PREPARED FOR THE URBAN DESIGN COMMISSION AND PLAN COMMISSION

Project Address: 529-557 State Street, 431-441 North Frances Street, and 432 West Gilman Street
Application Type: Demolition, Rezoning, and Conditional Use
Legistar File ID # [30532](#) and [30660](#)
Prepared By: Heather Stouder, AICP, Planning Division
 Report Includes Comments from other City Agencies, as noted

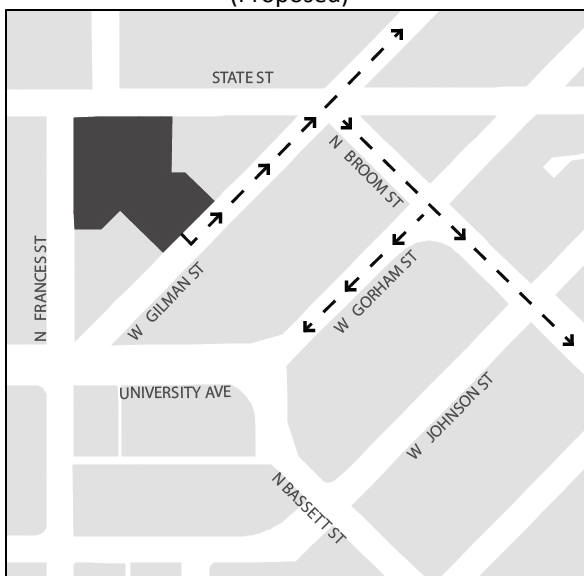
Parking - In a revision dated July 17, 2013, the applicant has added significantly more bicycle parking within the structured parking area, and has included a “flex” area for moped and automobile parking in the northern portion of the first floor of the parking area. The applicant has indicated that the July 17 revision is still a work in progress, but demonstrates that the space for bicycle and moped parking can be accommodated. One expected change in final plans submitted for staff review is that the support columns currently shown to impede access to parking stalls will be relocated.

There are now a total of 439 bicycle stalls in the structured parking area, which is 75% of the 586 stalls required by the zoning code for the residential uses in this building. Of these, 76% are on the first floor. 14% are standard two foot by six foot stalls on the floor, 11% are vertical racks on the walls, and 75% are stacked racks, which results in a wide variety of storage options for tenants based on whether their bicycles are used for daily transportation or occasional recreation. The applicant is also proposing 398 bicycle storage spaces within the residential units, based on previous experiences with tenants storing bicycles within their units. Finally, the July 17 revisions show 20 outdoor bicycle parking stalls within the Frances and Gilman Street rights-of-way. Details for these stalls will need to be coordinated with city staff.

The “flex” moped area is not detailed at this time to show the actual stalls, but a staff believes that the area (which is shown as 28 automobile parking stalls) can indeed accommodate approximately 140-150 moped stalls, which can reach the one stall per seven bedroom ratio advised in the staff report. Final plans submitted for staff review should show this area clearly delineated for moped use. If, based on a survey of incoming tenants, the applicant can show that some of the spaces are not necessary, they can be converted to automobile stalls

following a minor alteration of the conditional use. Assuming the “flex” area is completely utilized for mopeds, the total number of automobile stalls in the parking area will be 116. If the “flex” area were to be completely utilized for automobiles, this would be increased to 144 stalls.

This revised parking plan is much improved, and while it will still require a bicycle parking reduction granted by the Zoning Administrator, staff is much more comfortable supporting it, and believes that it helps the project to better meet Conditional Use Standard No. 5 as it relates to the adequacy of parking.

- e) A revised plan for the parking area which shows adequate space and a layout for moped parking to accommodate a ratio of one stall per seven bedrooms. A portion of this area may be utilized as automobile parking in the future following a minor alteration to the conditional use, if the applicant can demonstrate that the demand for moped parking is below that which is being provided. ~~If a portion of this space is not programmed as moped parking in the short term,~~ The applicant shall include a detailed management plan to ensure that mopeds are not parked outside of the building.

Traffic Options with Gilman Street Egress
(Proposed)

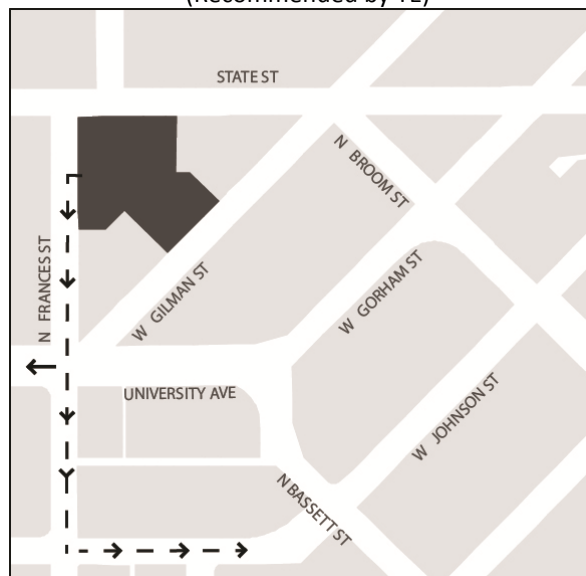
Frances Street Egress – As mentioned in the July 10 staff report, a vehicle egress route onto Frances Street has been recommended by the City Traffic Engineer (see Condition No. 32). The applicant has provided a Trip Generation and Distribution Study to support their desire to omit a vehicle egress from the parking area to North Frances Street. The City Traffic Engineer has responded to this in a one-page memo, and both of these items are included in the Plan Commission packet.

The applicant has submitted a revised plan (dated July 17) showing this egress route, but prefers to omit it in order to maintain a complete commercial frontage on North Frances Street and minimize vehicle traffic on this block. Staff appreciates this argument, and agrees that the design and function of the ground floor of the North Frances Street facade would be much better without this vehicle egress.

However, many complicated traffic issues arise from the current layout, as noted by Traffic Engineering staff, who will be available to answer questions at the July 22 Plan Commission meeting. Since Gilman Street is one-way to the northeast on this block, all vehicles exiting the site will head northeast on Gilman and approach the intersection of Gilman, State, and Broom Streets, which is heavily used by pedestrians. From here, vehicles will either move straight through the State Street intersection or turn right onto Broom Street. Vehicles ultimately heading East are likely to cross State street and use Gilman Street to get to Wisconsin Avenue. Vehicles ultimately heading west would need to again turn right onto Gorham/University. Alternatively, if the Frances Street egress is incorporated into the project, all traffic heading westward would presumably utilize it, and most traffic heading East may also utilize it to avoid crossing State Street (see figures below). Overall, this would result in a better distribution and significantly less traffic entering the Gilman/State/Broom intersection.

Staff understands that the conversion of this portion of West Gilman to a two-way street would be extremely difficult due to its narrow width and considerable challenges in designing a safe 5-way intersection where Gilman meets University Avenue. If there was a clear solution that would better distribute vehicle traffic from this project while maintaining safety and the pedestrian emphasis of State Street, staff would prefer to omit the Frances Street egress. However, absent this solution, staff maintains that it should be included.
